GLENDALE	<b>SOLICITATION ADDENDUM</b>		<b>CITY OF GLENDALE</b> <b>Procurement Division</b> <b>5850 W. Glendale Avenue</b> <b>Suite 317</b> <b>Glendale, AZ 85301</b> <b>Phone: (623) 930-2866</b>
	Solicitation Number: <b>IFB 18-59</b> <b>Addendum No. 2</b>	Page 1 of 4	
Solicitation Due Date: July 6, 2018 2:00 P.M. (Local Time)

## IFB 18-59

### STREET LIGHT POLES, ARMS AND ACCESSORIES ADDENDUM NO. 2

REVISED A3 - USE IN APS AREA

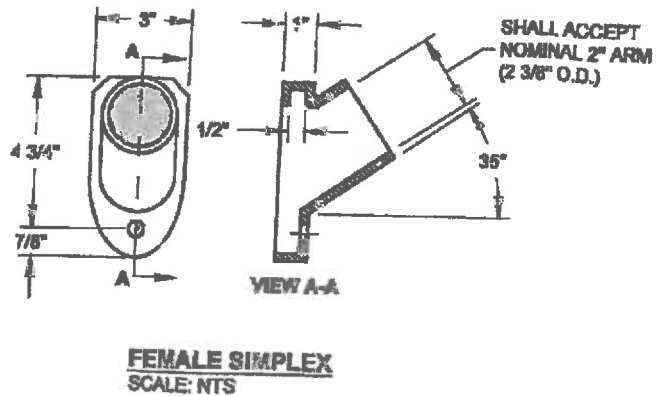
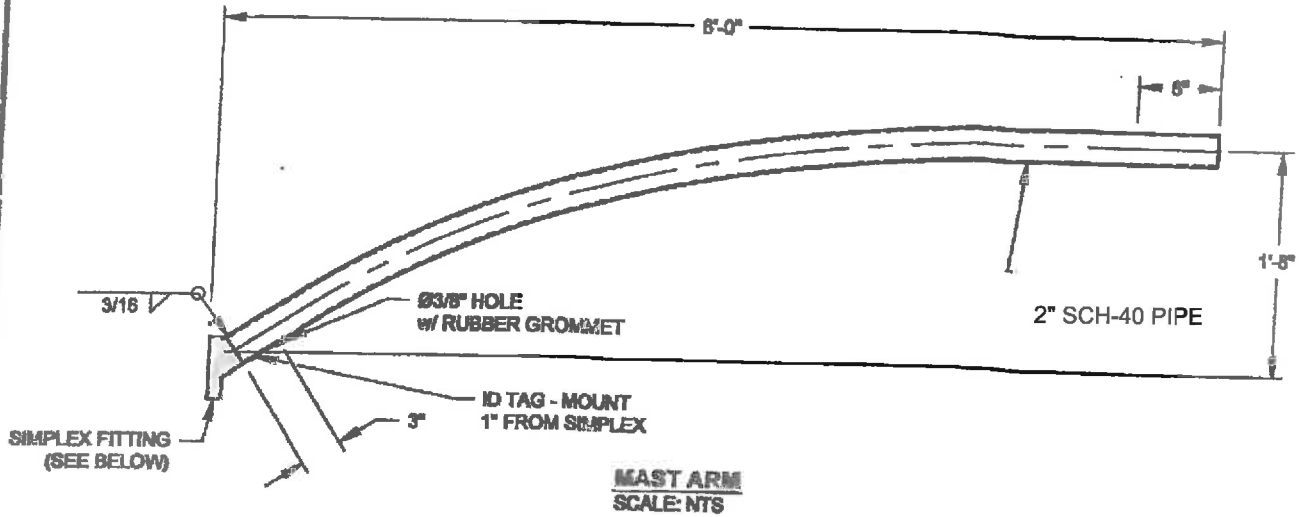
- 1.2 **Question:** Spec states that arms must be fabricated from 2" sch. 40 Pipe but details A3, A4, A6, Grand Ave, and Modified G are all using different pipe. Which is correct, details, or specification?

- 3. DELETE the following from ATTACHMENT I, SPECIFICATION DIAGRAMS:
A3-USE IN APS AREA RESIDENTIAL MAST ARM USE w/ P3 POLE
A4 (GALVANIZED)-USE IN APS AREA COLLECTOR STREETS USE w/ P3 POLE
A4 (BRONZE) WESTGATE STREETS USE w/ P3 POLE (BRONZE)
A6 ARTERIAL STREETS USE w/ P1, P9 OR P10 POLE
GRAND AVE BREAK-AWAY BASE MAST ARM, and
MODIFIED G-USE NEAR GRAND AVE BRIDGE & OVERPASSES USE w/ MODIFIED G POLE

**Response:** All mast arms shall be fabricated as Schedule 40 steel standard pipes. See revised Specification Diagrams A3, A4, A6, Grand Ave Breakaway Base Mast Arm, and Modified G attached below.

- REVISED A3-USE IN APS AREA RESIDENTIAL MAST ARM USE w/ P3 POLE
REVISED A4 (GALVANIZED)-USE IN APS AREA COLLECTOR STREETS USE w/ P3 POLE
REVISED A4 (BRONZE) WESTGATE STREETS USE w/ P3 POLE (BRONZE)
REVISED A6 ARTERIAL STREETS USE w/ P1, P9 OR P10 POLE
REVISED GRAND AVE BREAK-AWAY BASE MAST ARM, and
REVISED MODIFIED G-USE NEAR GRAND AVE BRIDGE & OVERPASSES USE w/ MODIFIED G POLE
